CONSTRUCTION OF NEW MUNICIPAL SOFTBALL PARK REBID

PROJECT NO.: 08-18-C28-608

A D D E N D U M NO. 1

ADDENDUM No 1
SOFTBALL FIELD FACILITIES
MUNICIPAL PARK
McALLEN, TEXAS

Project No.: 33348.001
Issued: 07/11/2018
Drawn By: G.Q.
Checked By: B.S.
Scale: AS SHOWN
Sheet Title: WALL SECTIONS
A4.2
Sheet Number

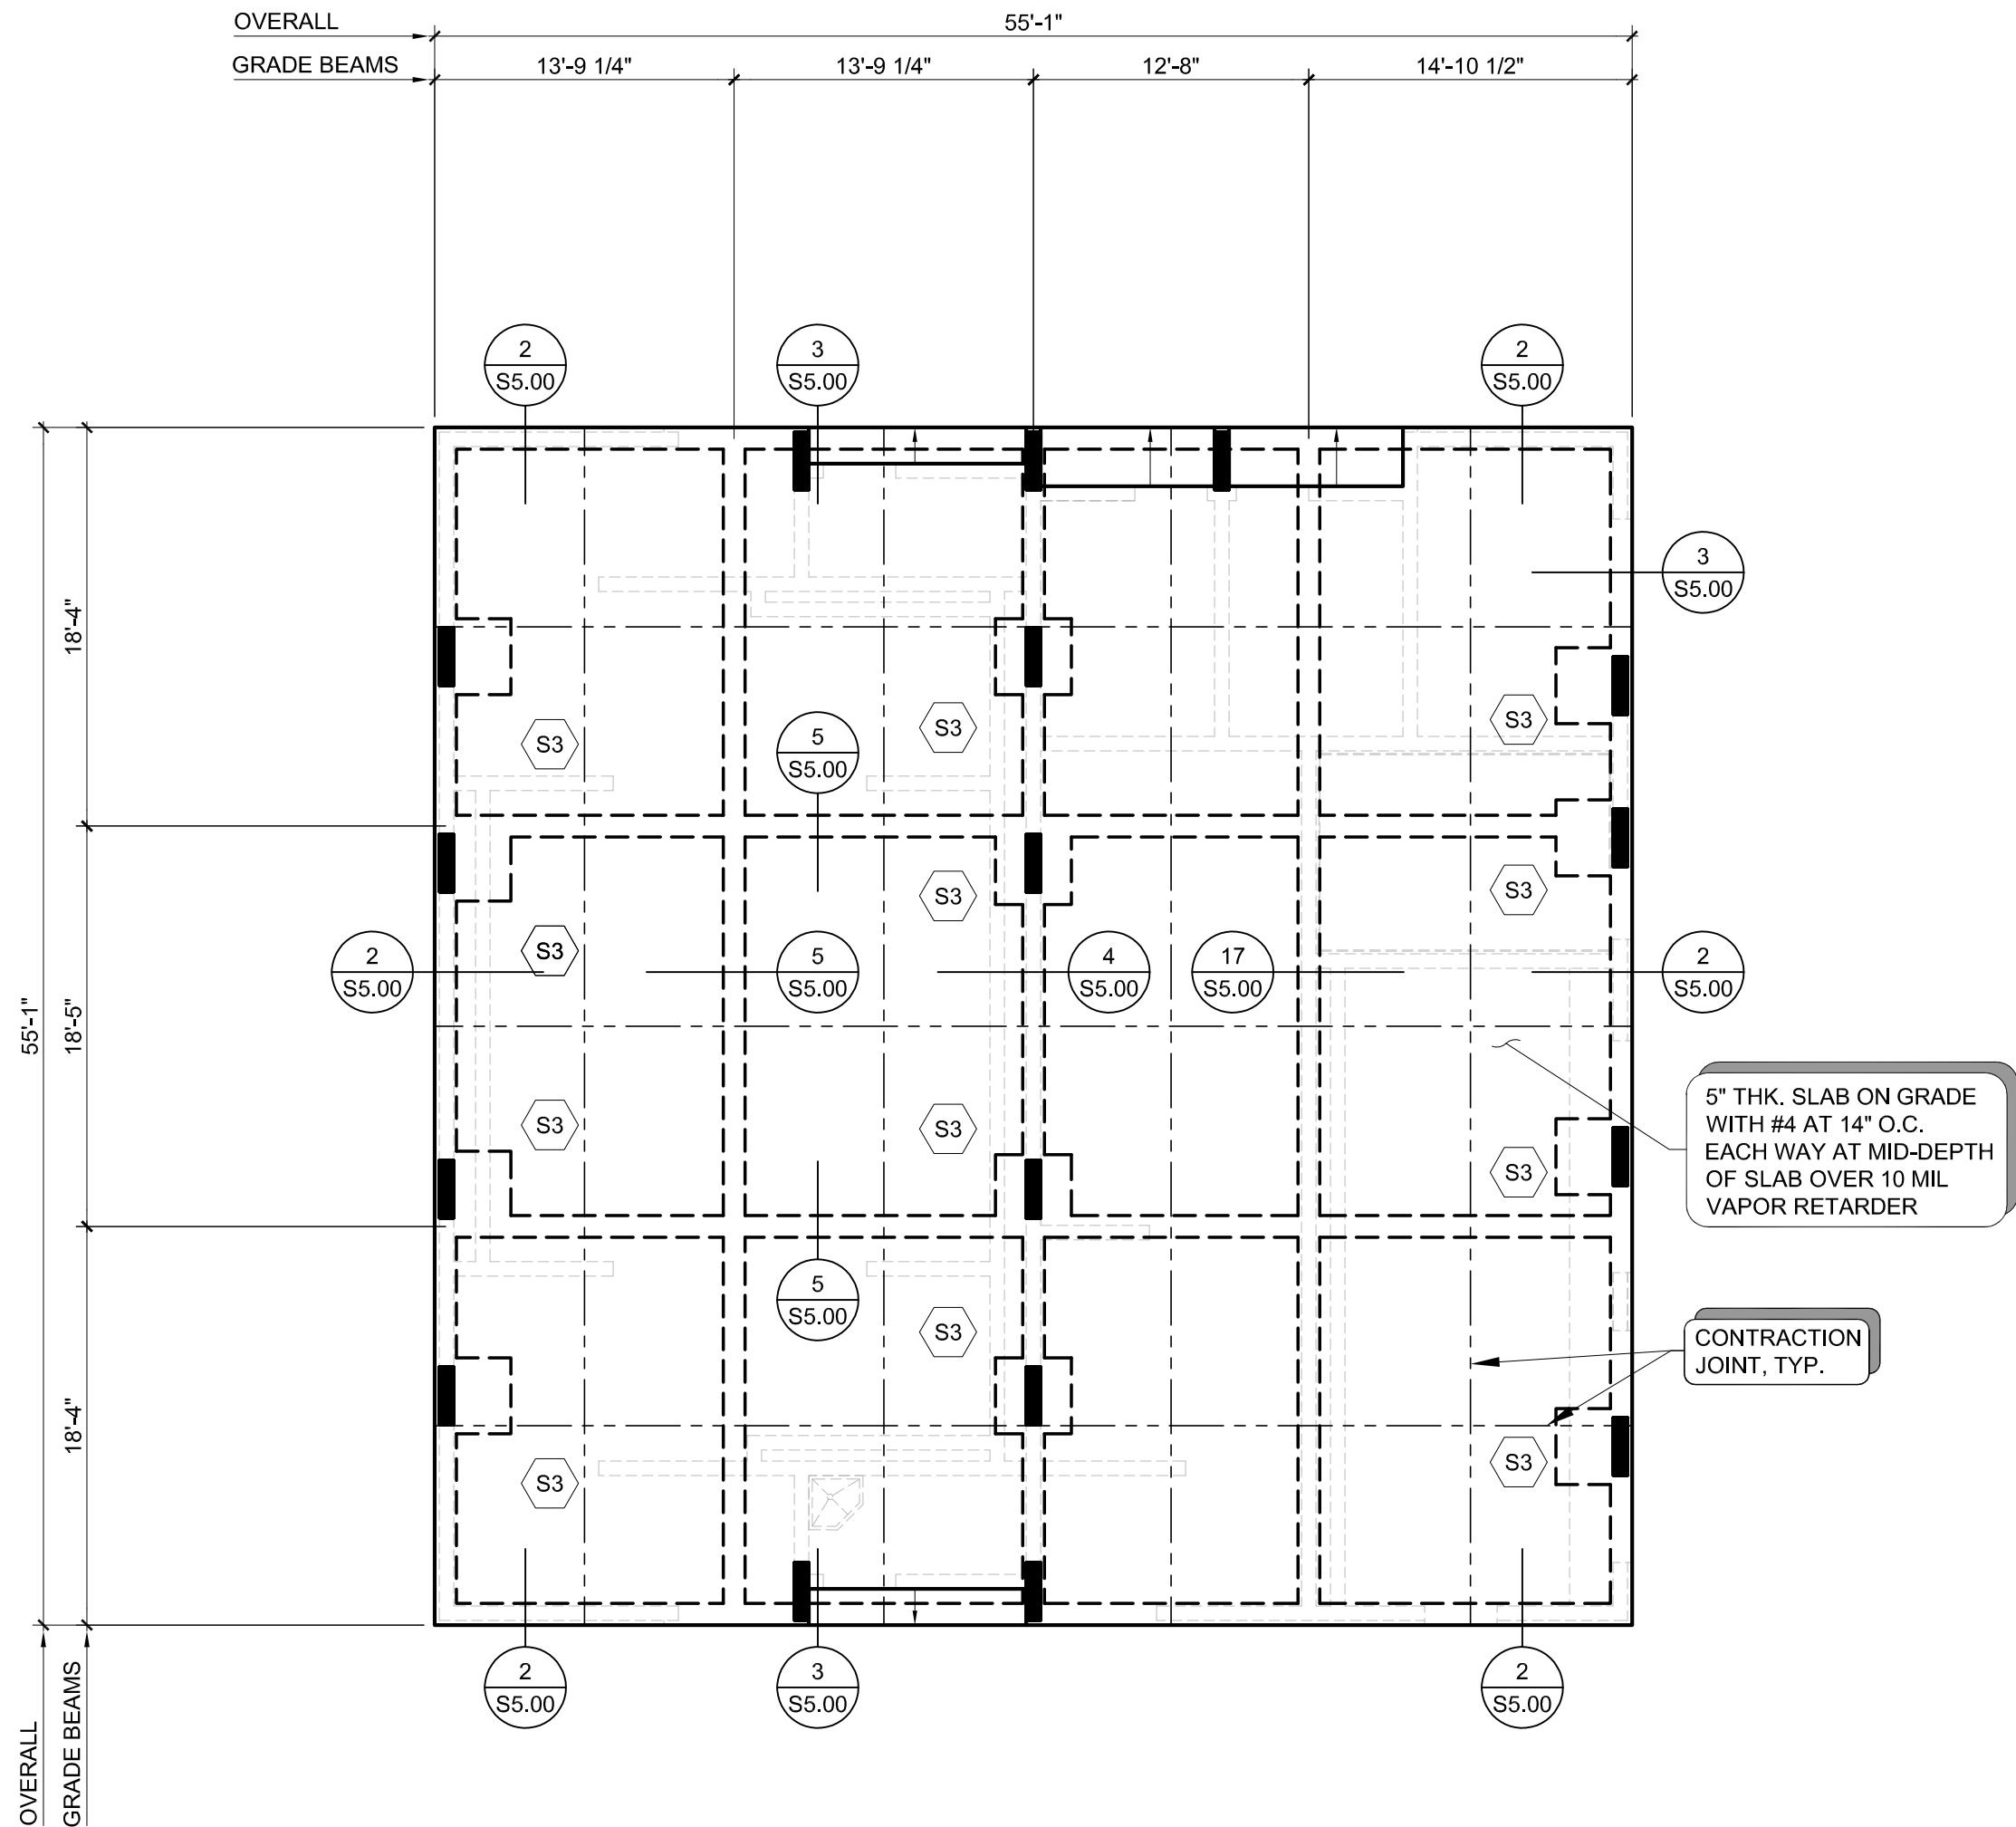
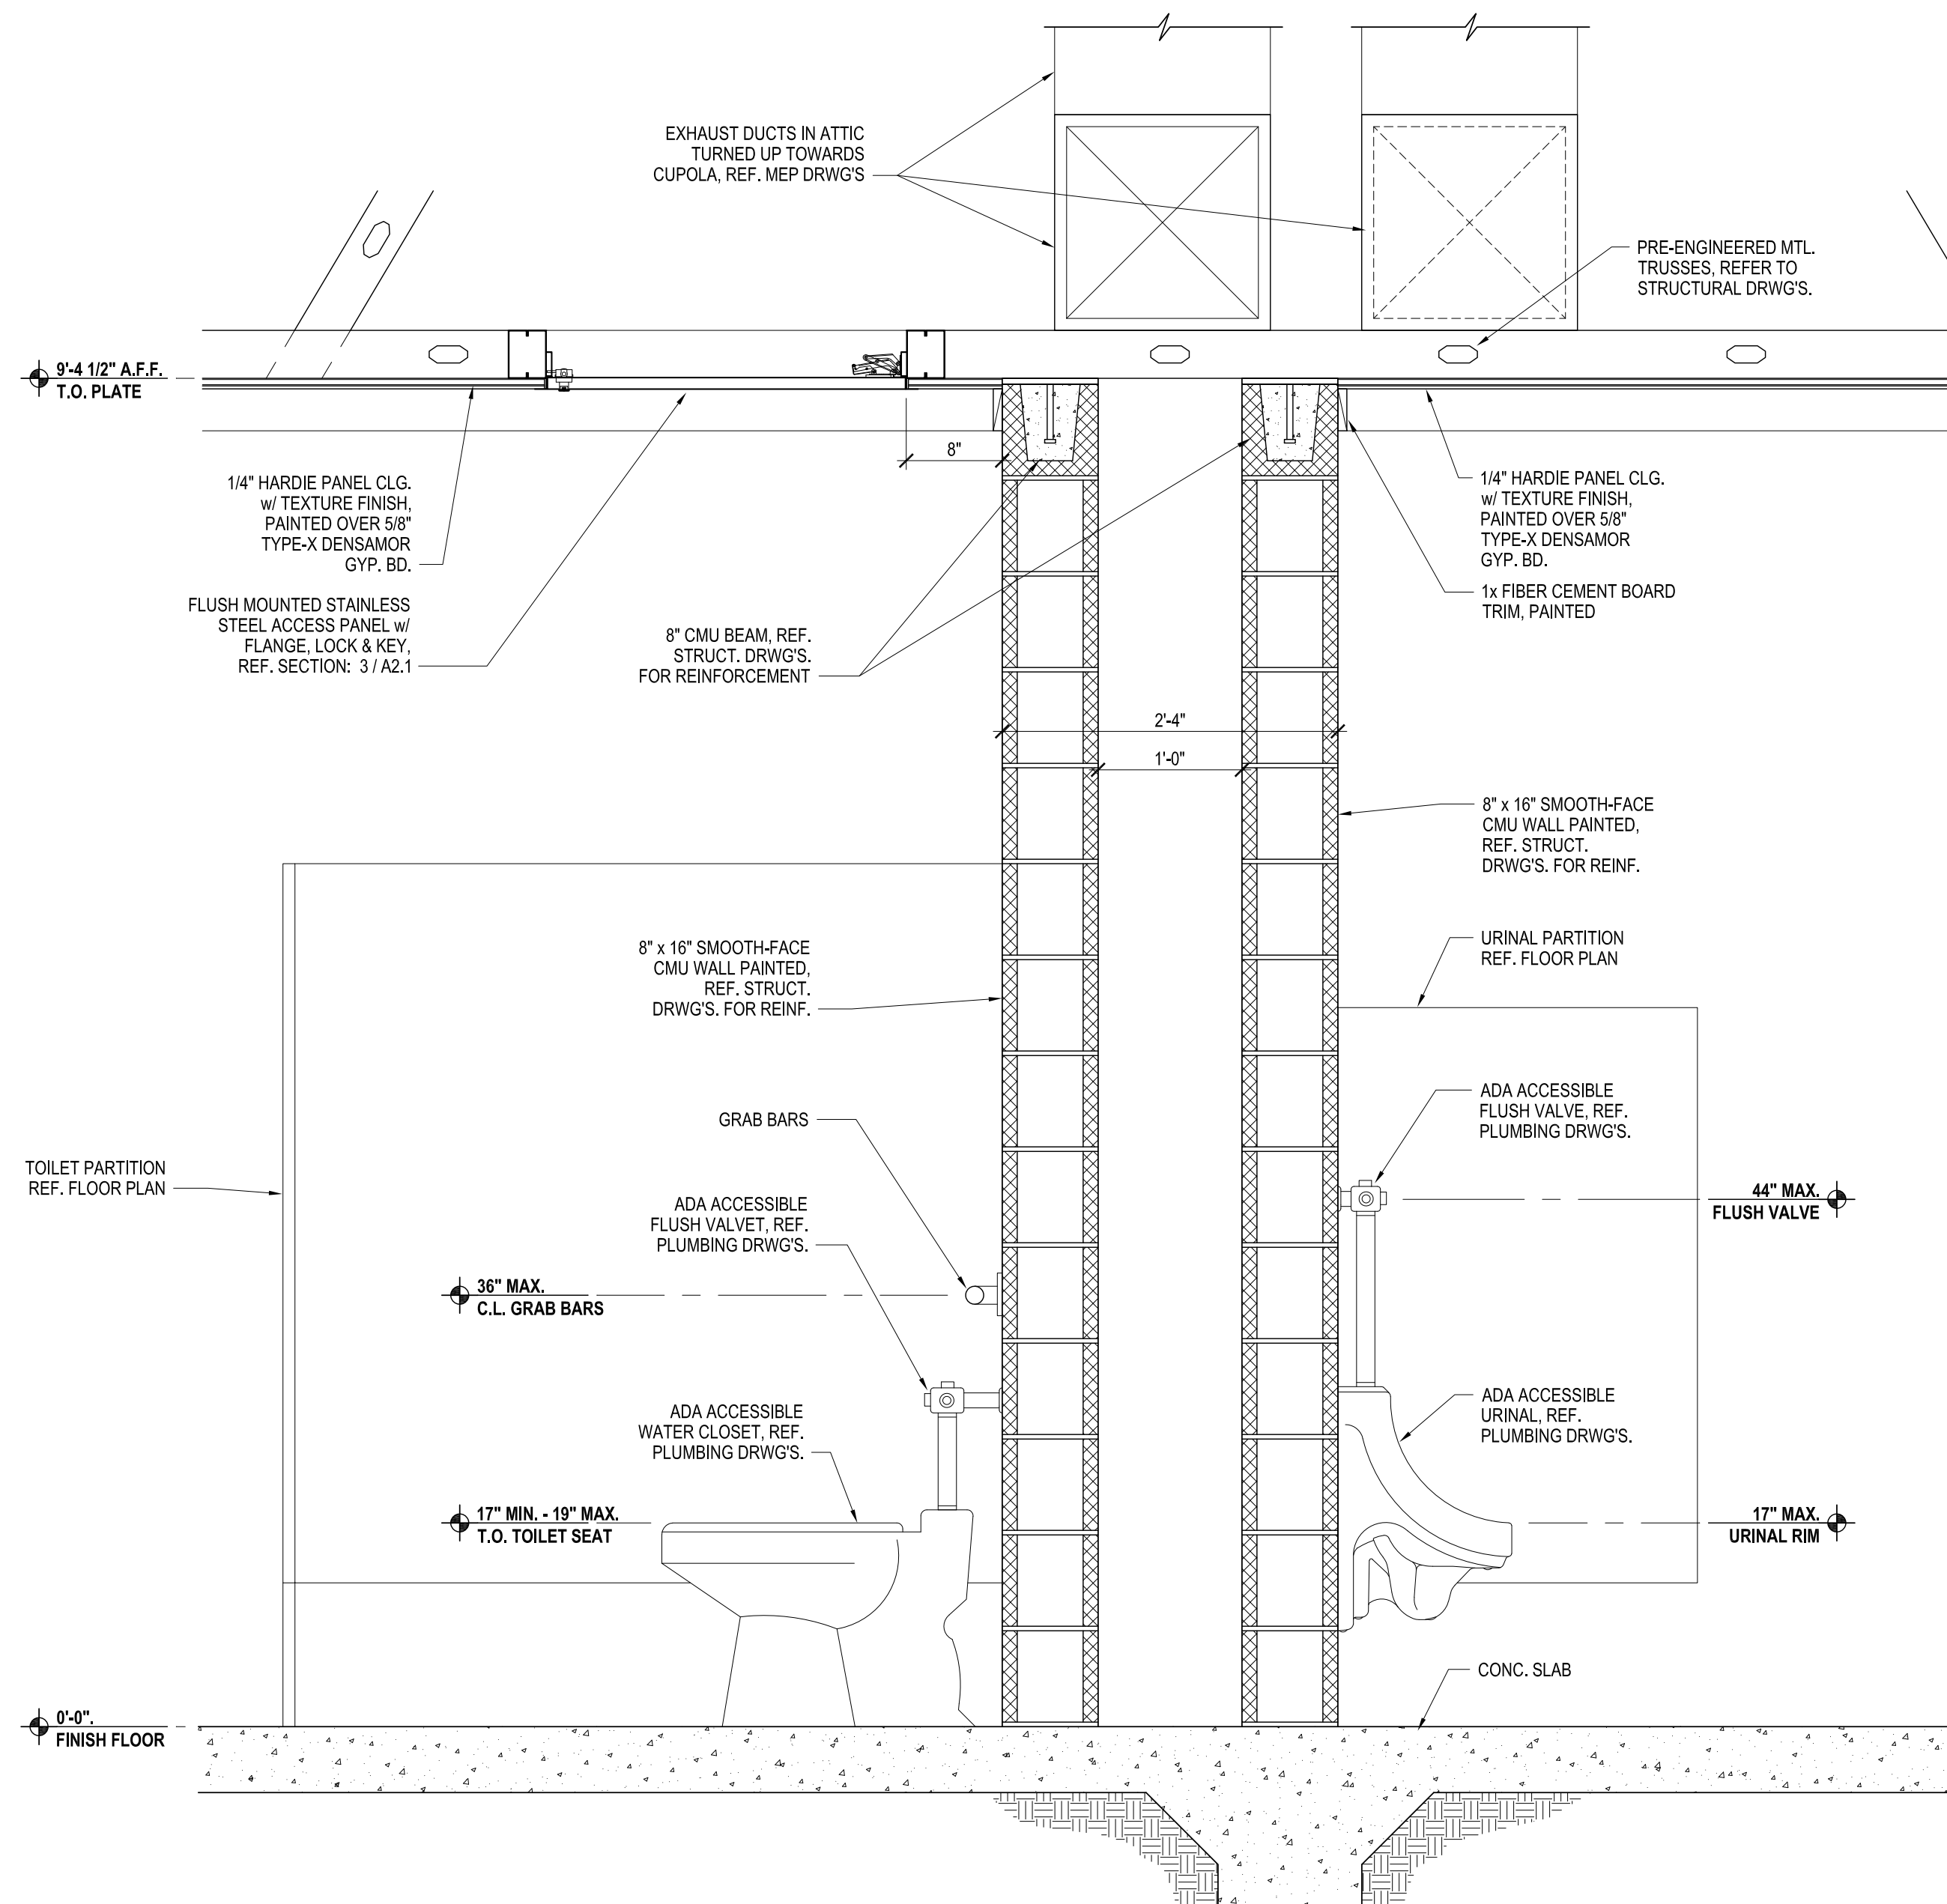
- A2.1 Added outline of Cupola wall above. Added RCP key note #7 & revised key note #8.
- A2.2 Relocated ADA urinal, added ADA notes & dimensions.
- A2.3 Relocated ADA urinal, added ADA notes & dimensions.
- A3.1 Added Cupola & material call outs.
- A4.1 Added wall section at Cupola. Added ADA notes & dimensions.
- A4.2 Added wall detail at Cupola.
